DANIEL LETTER REVISED PLANS

Re: NVA Properties of IL Sands Road Project
Revised Site Plan and Landscape Plan (Rezoning and PUD)
Request for Variations from Stormwater Ordinance

ALTERNATE SITE PLAN

Revised Preliminary Landscape Plan

AGE-1	1" = 60'	G985	JACOB & HEFNER ASSOCIATES 1333 Butterfield Rd, Suite 300, Downers Grove, IL 60515 PHONE: (630) 652-4600, FAX: (630) 652-4601 www.jacobandhefner.com	ALTERNATE SITE PLAN GRADING EXHIBIT NVA TRUCKING FACILITY EXPANSION NVA PROP IL LLC CRYSTAL LAKE, IL

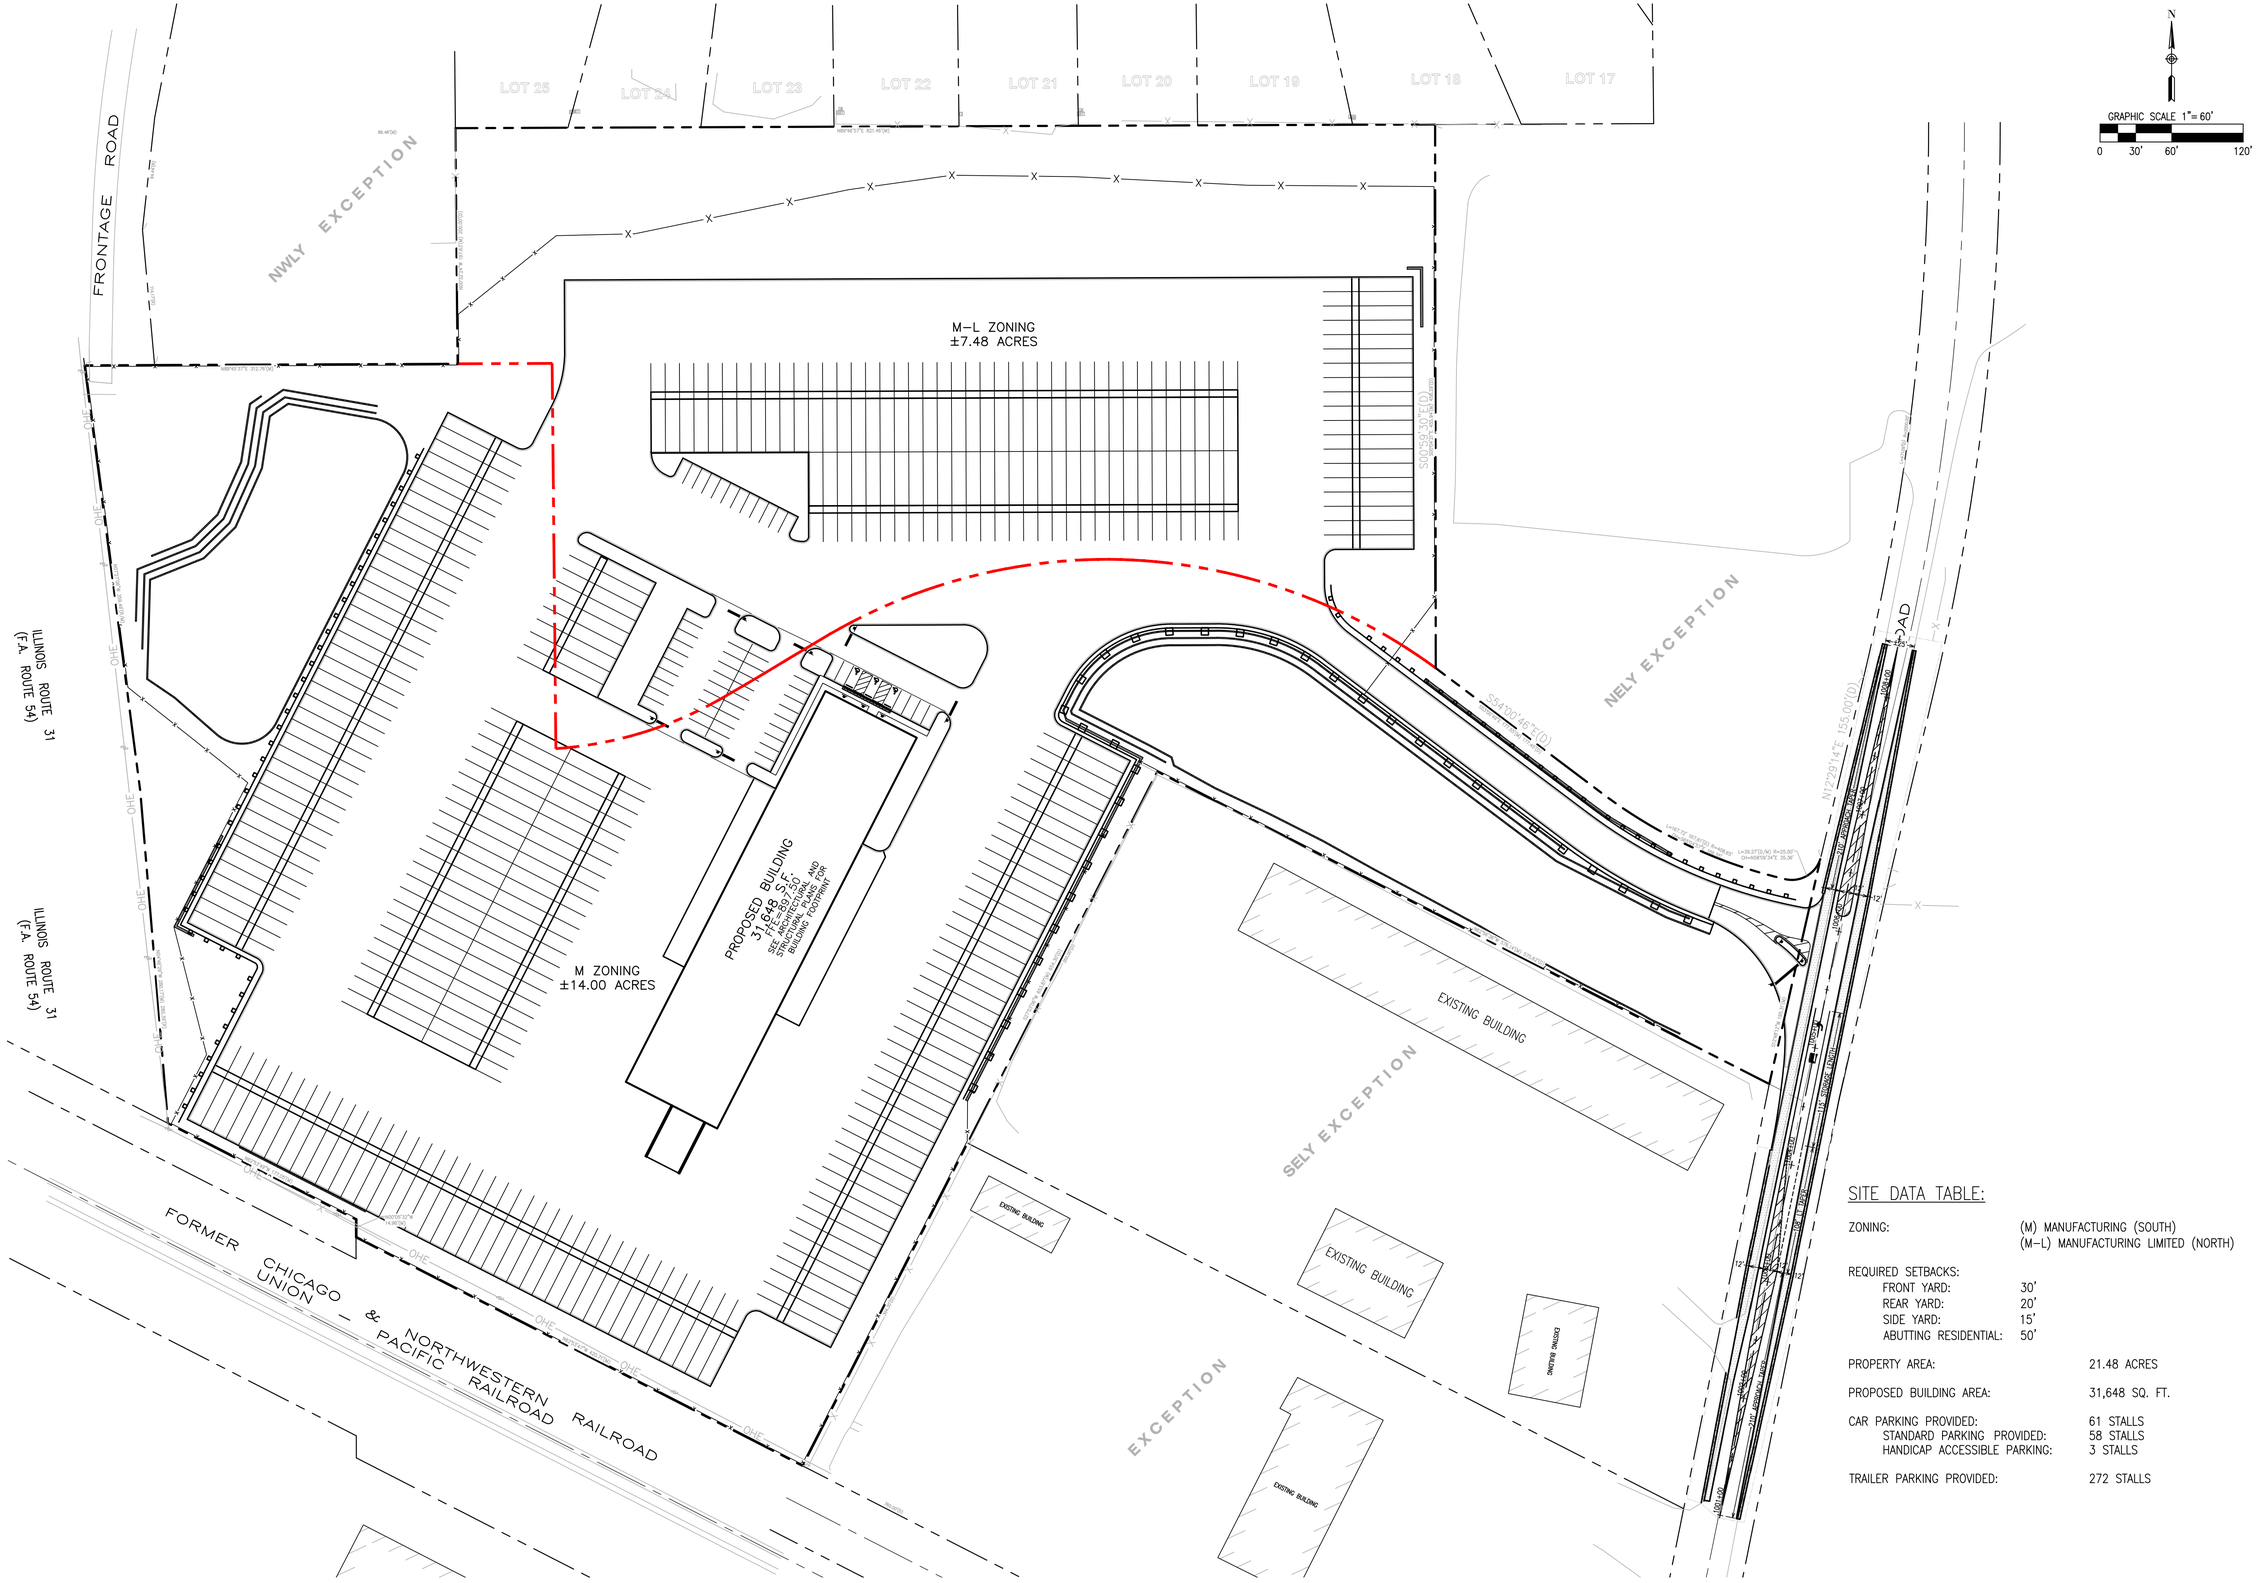
Items 1-2 reflect the current set of drawings with a 120-foot open space area that includes substantial grading between the north lot line and the north edge of the improved area on NVA's property. The resulting elevations allow for a change in elevation of as much as 27 feet to create a hill upon which the trees and fencing will be placed as shown in Item 3. This will better screen

the residences north of NVA's property. The use will remain the same, only the north row of parking and storage spaces will be eliminated.
